# **Dart Aerospace Ltd**

NCR: 3	1460	W	ORK OR	DER NON-CONFORMANCI	E (NCR)	•		
		Description of NC		Corrective Action Section B		Verification	Approval	Approval
DATE	STEP	Section A	Initial Chief Eng	Action Description Chief Eng	Sign & Date	Section C	Chief Eng	QC Inspector
Q.03.04	3	1.100 DIM IS 1.084	P	PART ACCEPTABLE DUES	(		4	
-210 3.07			67.63.04 pr	NUT AFFECT STRESS	S.	/ /	67.03.04	'/
			QS1 642	REPURT. for programy	02/04/04	orary	Dr. 05/1047	Poses of
<b>ડ</b> ટ.ज.ળ	3	(151NK \$0.610 100"	W	PARTACCEPTABLE	1/0/		4)	
		CISINK \$0.610 PIQUE OFY (Z) AFFECTED	08.67.67	PARTACCEPTABLE REF DS EMAIL	MIP	/	08.67.07 pe	foot
			95142			180AT7	QSIUTZ	1000
						,

Part Number: D3196-1

Subject: RE: NCR D3196-1/-3/-4

Inspection Dwg: D3196 Rev: C Page 1 of 1

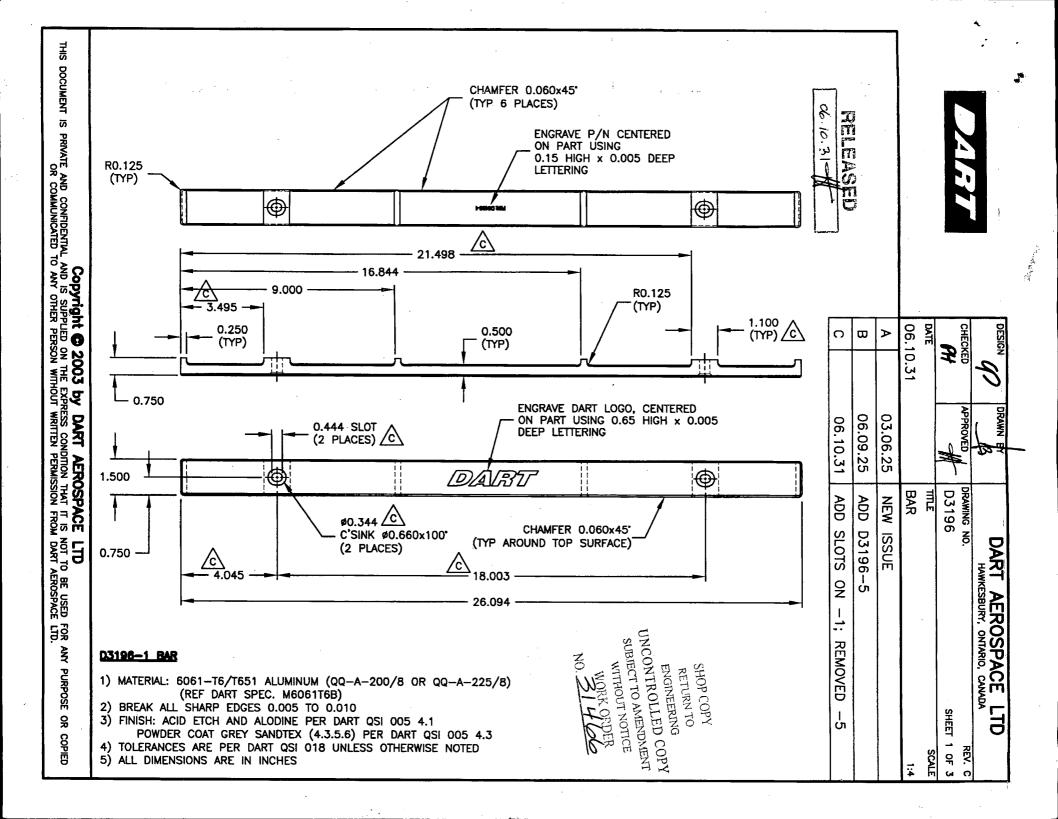
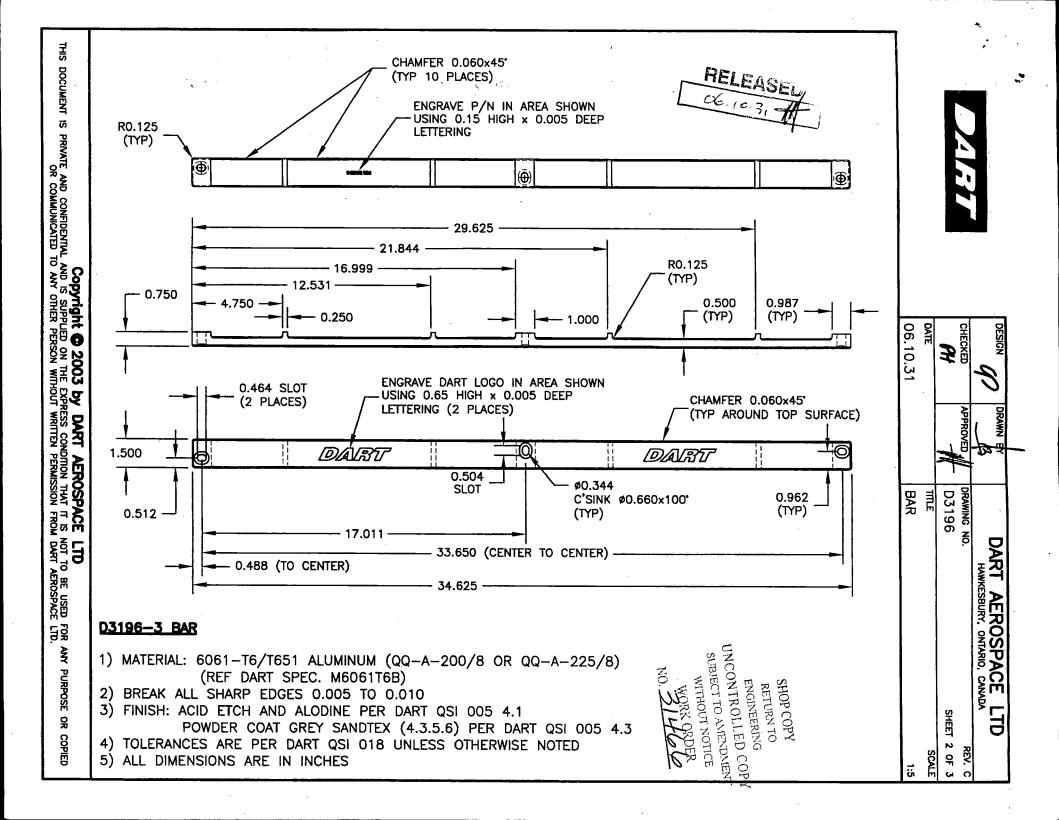
Checking into an NCR for some -3's they are currently making, I found out there has been confusion as to the direction of the 0.660 dim in the Ø0.660x100° c'sink. They were modifying the program to make the dim the other way, which made the c'sink too small.

I checked stock. We have some D3196-1 in stock, the c'sink on one is 0.664" (good), the rest are about 0.610" (min). The MS spec gives the range of screw head widths as 0.617 - 0.635, which is the 'sharp' dimension, ie the dim to keep the top of the head below the part surface (The edge of the head is chamfered, and the actual max diameter of the screw is about 0.590"). The two listed dims are from the same batch, so I think its more than just confusion over the dwg dim. I made an NCR to ensure the programs are correct, and to add a ref dim to show the direction of the 0.660" (or otherwise clarify it). Chances are, we've shipped a bunch like this.

I think the deviation is acceptable. Attached pics (one showing good, one bad) show that even though it may stick up slightly above the surface, the actual corners of the screw don't go past the edges of the c'sink. The belt shouldn't fray over this bolt as the bolt holes are located on the solid legs of the bar, and the belts don't go straight down, they'd be coming out to go over the occupant's shoulders. I would have them get the w/o's for these bars and sign of deviations using the 0.610" dim as the minimum allowable.

I agree with you. The parts are acceptable. I wonder how they had the flexibility to screw around with the CNC program? Guess we better make it crystal clear on the drawing.
